2200444

SSD-8586218 - TEMPERATURE CONTROLLED WAREHOUSE FACILITY SECTION 4.55(1) MODIFICATION APPLICATION

Figure 1 Site Plan

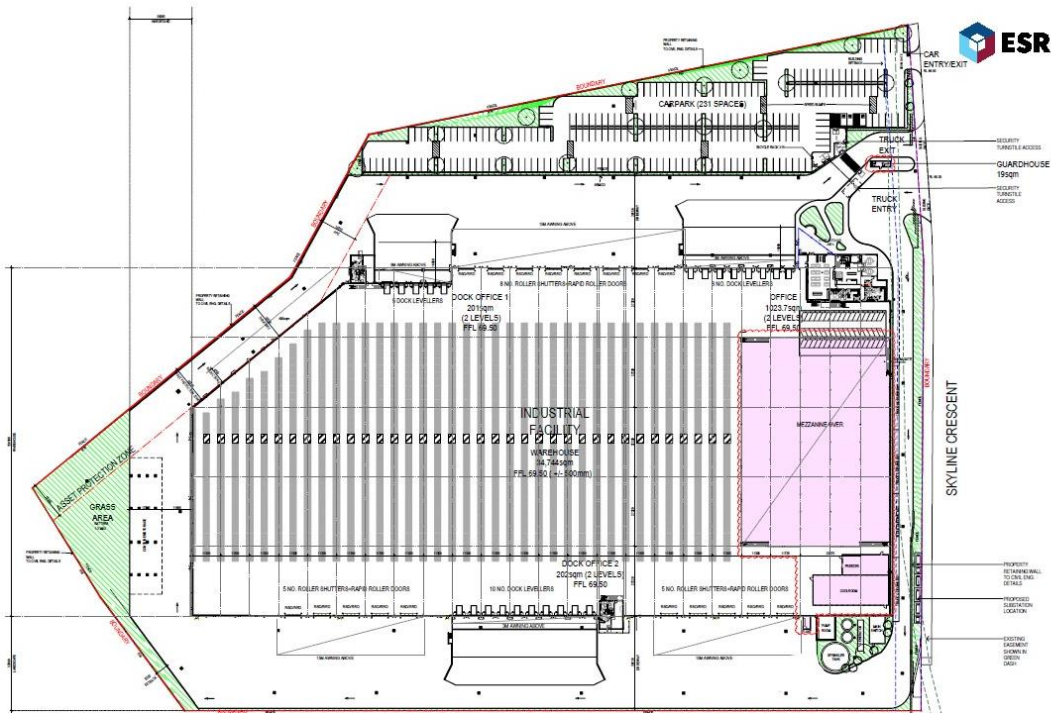
Modification 1 sought approval for the installation of an additional cool room and freezer located on the south eastern side of the warehouse (among other matters). Refer to **Figure 1** above for the location and size of the cool room and freezer as originally submitted with the Mod 1 application. The size of the cool room and freezer were unintentionally reduced on the Site Plan submitted in response to the DPIE's request for additional information. The incorrect Site Plan with the smaller cool room and freezer was subsequently approved and stamped by the DPIE. It is requested that this error is corrected by replacing the approved Site Plan with the Site Plan originally submitted with Mod 1.

The correct Site Plan has the same drawing reference as the incorrect Site Plan approved under Mod 1. Therefore, no modifications are proposed to the notice of determination. The only modification proposed is that the stamped Site Plan is replaced with the Site Plan originally submitted with Mod 1 and provided again as **Attachment 1**.
